SUBJECT: Blankenship Visitor Bleachers

We were asked to evaluate the bleachers at Blankenship Field in terms of structural soundness, life safety issues, and ADA compliance.

INSPECTION REPORT

**Re: Bleacher Framing Review
Blankenship Field/Jack Armstrong Stadium
Oak Ridge Schools
Oak Ridge, Tennessee
CWE Project No. 2013187.00**

Photo 6: Visitor's Bleacher – Concrete Cracking at Previous Pedestal Repair

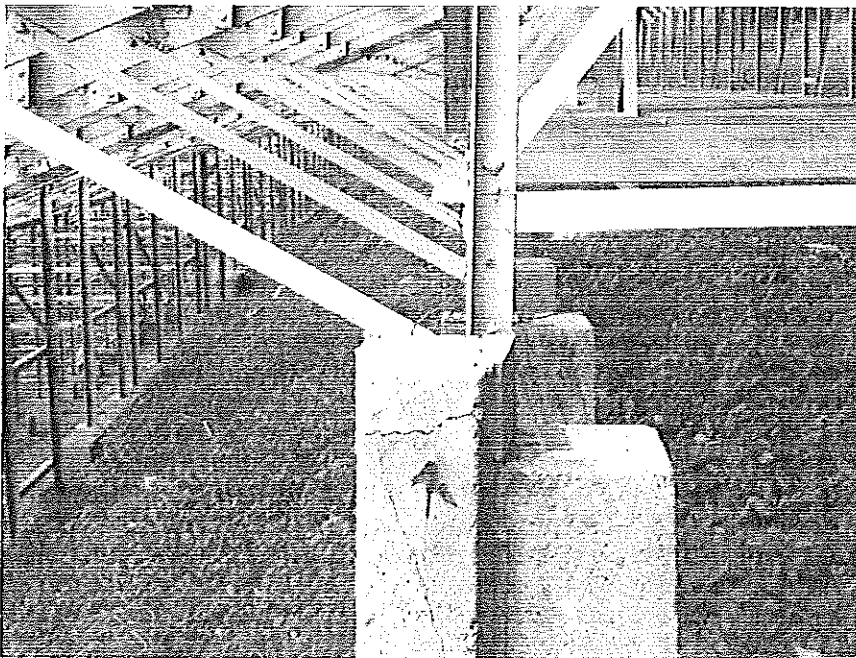
3. Previously repaired pedestals supporting bleachers were observed to be cracked. It is noted that the repairs differ from that of the specified details and the cracking appears only to be in the plain concrete encasement above the base plate. Refer to Photos 6 and 7 for this condition.

Photo 15: Home Bleachers – Concrete on Grade Area

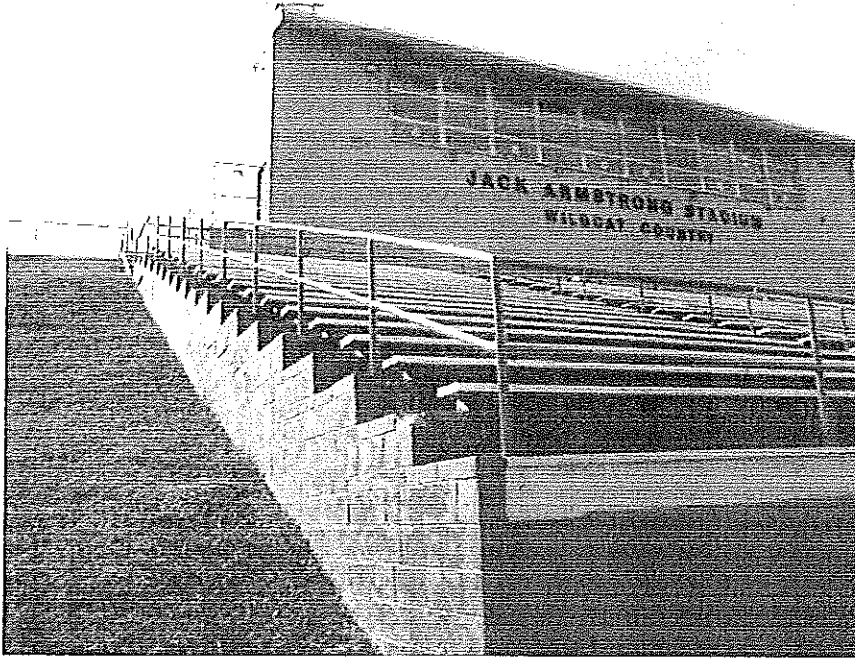
typical condition. The distance between footboards and grade is relatively consistent and is much less than that for the Visitor's side. The upper level Home area seating consists of aluminum seatboards mounted to a stepped concrete-on-grade structure. The grade slopes with the seating and it is not an elevated system. See Photo 15 for the concrete supported system.

Photo 17: Home Side Metal Bleacher Area – Typical Framing

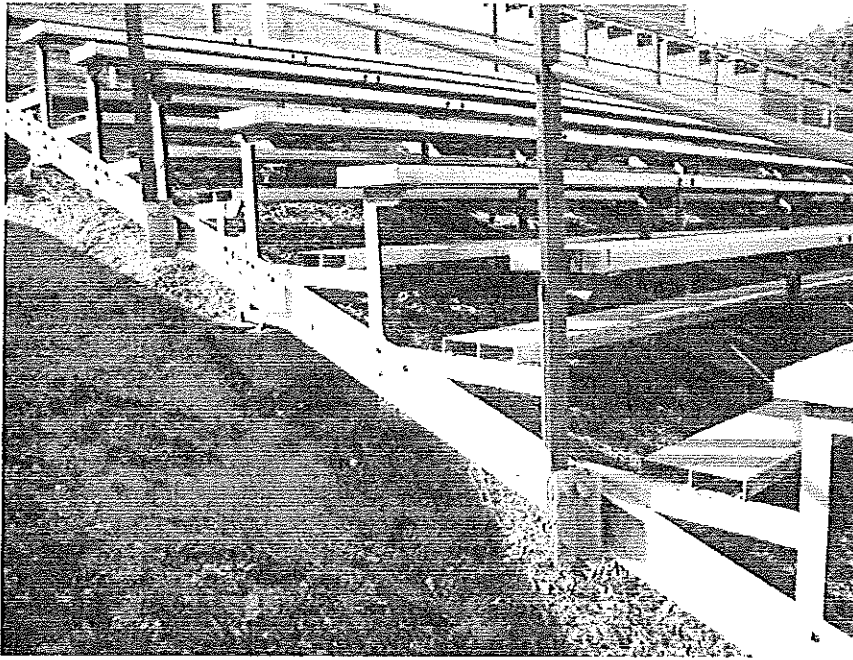
We visited the site on October 14, 2013. Refer to the General Arrangement Sketch S1 attached for the layout of bleachers and of elements to be discussed. The Visitor's area bleachers are on the East side of Blankenship field and are comprised entirely of an elevated system. The system consists of aluminum footboards and seatboards supported by painted steel framing. It is our understanding the system has been adapted at some point from a wood seatboard and footboard system supported by the existing steel framing. Refer to Photo 1 for an overall view of Visitor's side and Photos 2 & 3 for typical support framing. The Home area bleachers are on the West side of the field and include two distinctly different seating systems. The lower level is similar to Visitor's area in that it has aluminum footboards and seatboards supported by painted steel framing. However, the grade slopes upward with the tiered seating. See Photo 17 for a

Photo 25: Wildcat Stair – Erosion/Scouring

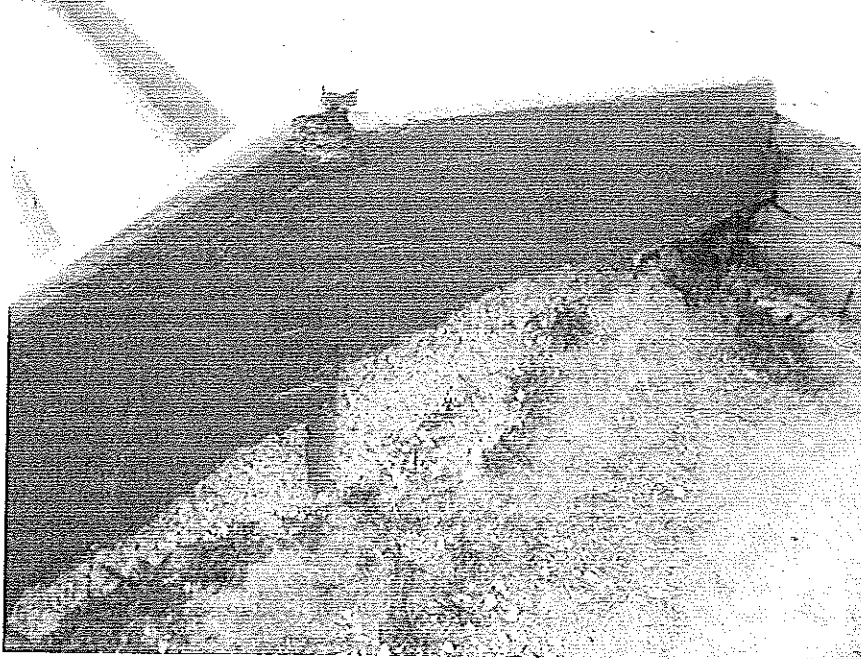
6. Scouring and erosion of concrete stairs and surrounding grade was observed at "Wildcat Crossing Stair" (Refer to Photo 25). Spalled concrete, exposed reinforcement, and deteriorated concrete was found at Wildcat stair (See Photo 26).

The concrete at the Wildcat stair needs to be repaired or replaced. The handrail system for the stair should be replaced.
